Changes made since Public Meeting 1 (July 27, 2023)

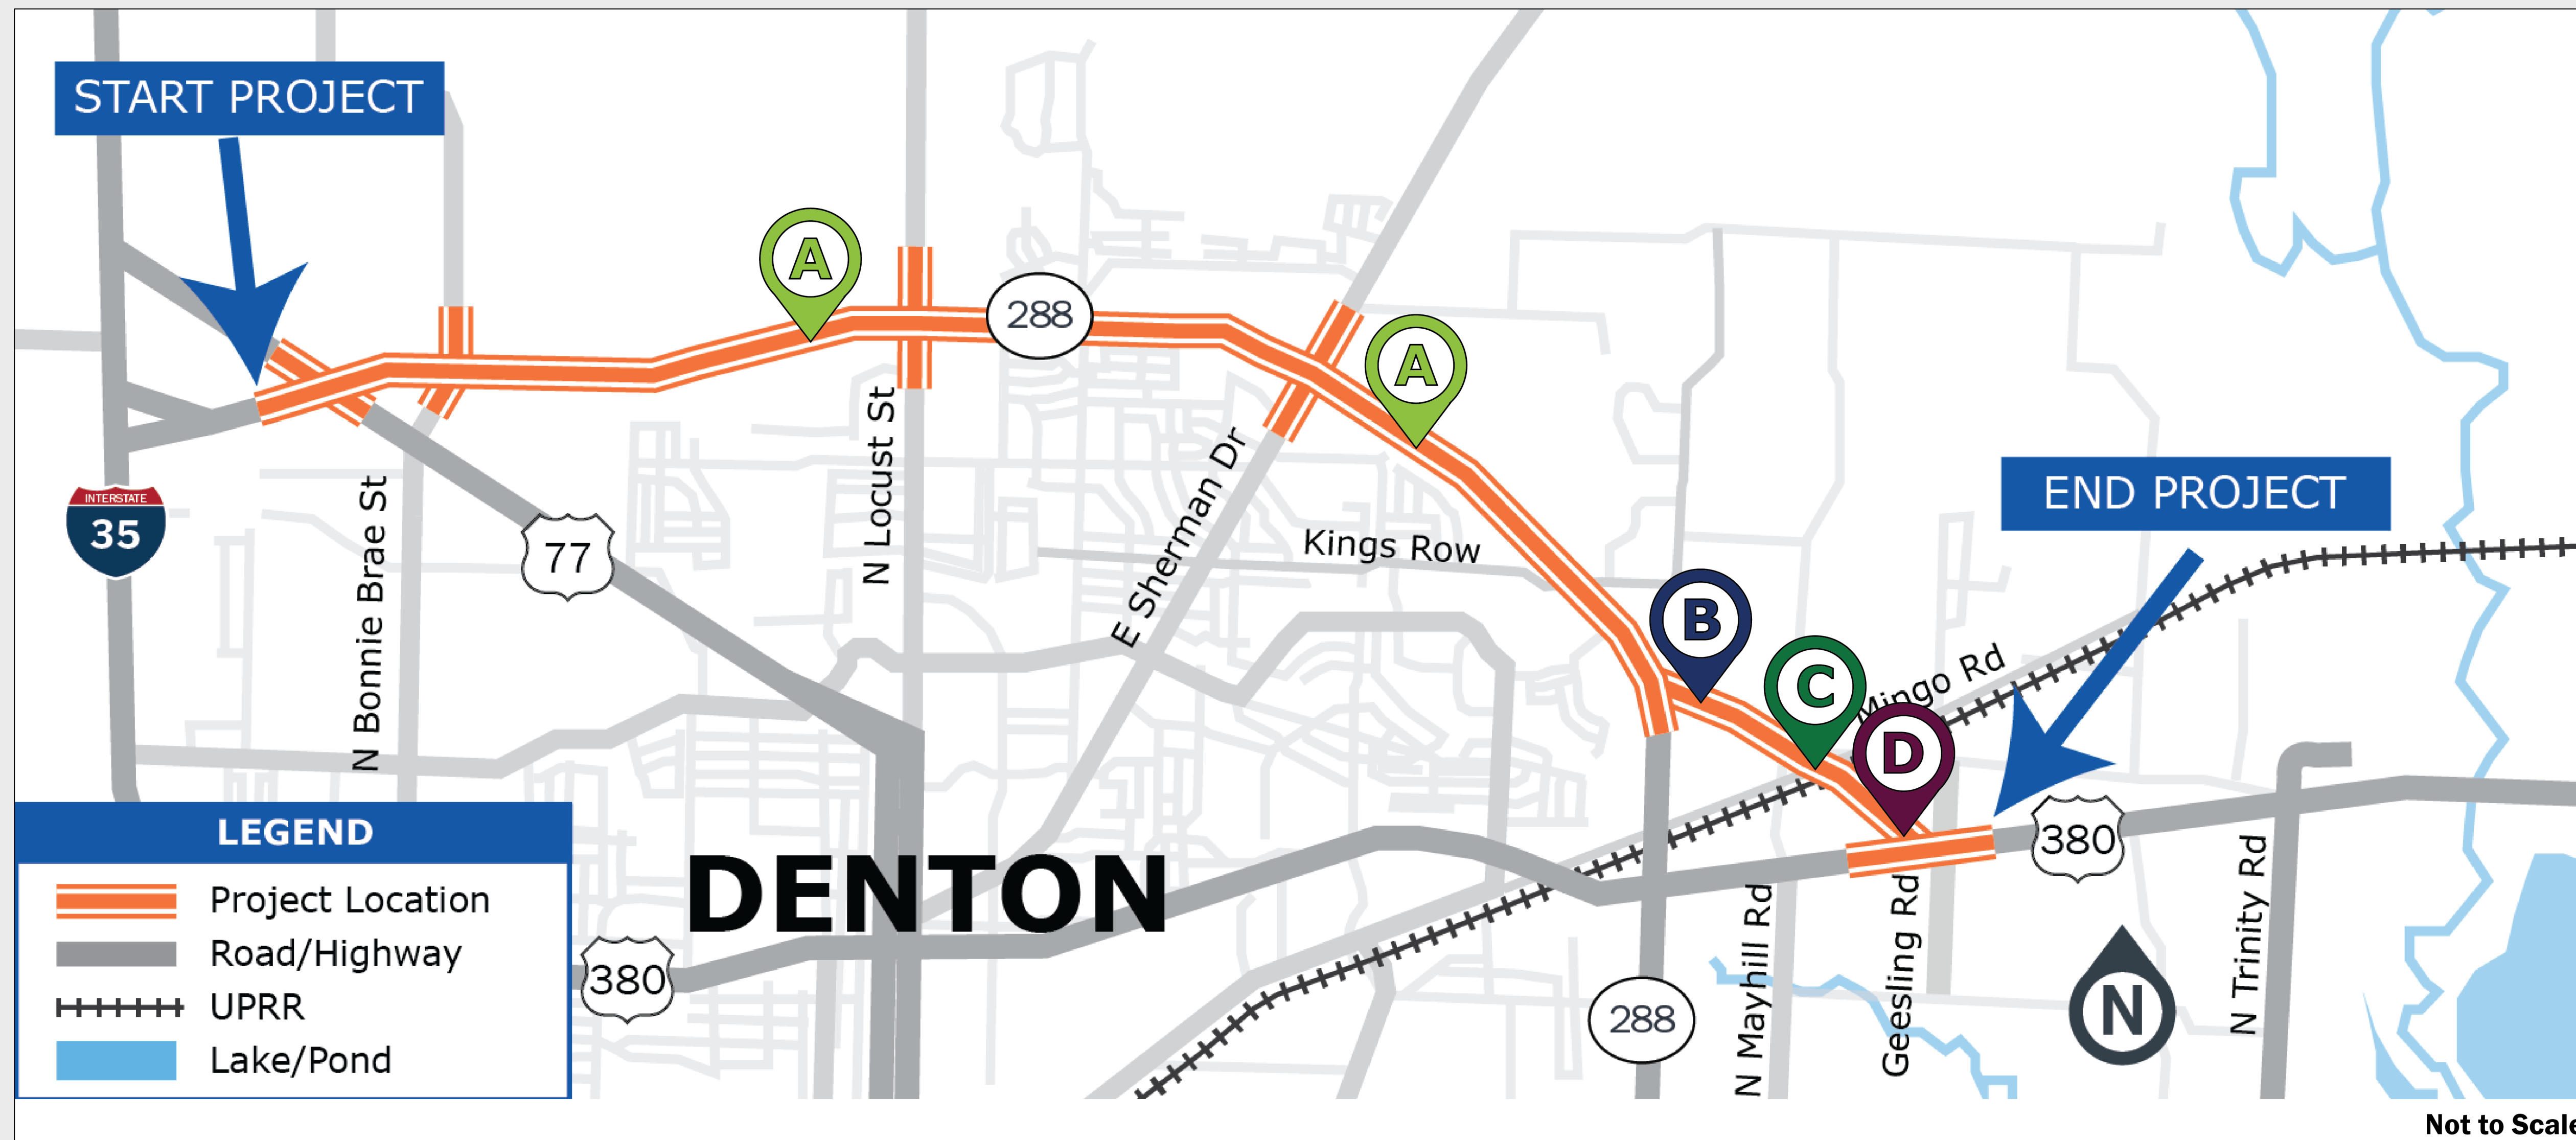
A: FM 428 (Sherman Drive) Ramps

- Sherman Drive braided ramp removed and extended exit ramp through Locust Street to access Sherman Drive
- Entrance and exit ramps reversed to allow for westbound exit and eastbound entrance to SL 288 for better access and operations

C: Connector Revisions

Frontage road and access eliminated from Kings Row to US 380 for safety and improved connectivity

B: Kings Row/Windsor Drive

Kings Row through-connection eliminated, new Kings Row connection made by extending Deerwood Parkway and Windsor Drive to the SL 288 at-grade intersection east

D: Connector Alignment

Revised schematic alignment closer to the original feasibility study alignment is selected to move forward for schematic design to minimize home and business displacements
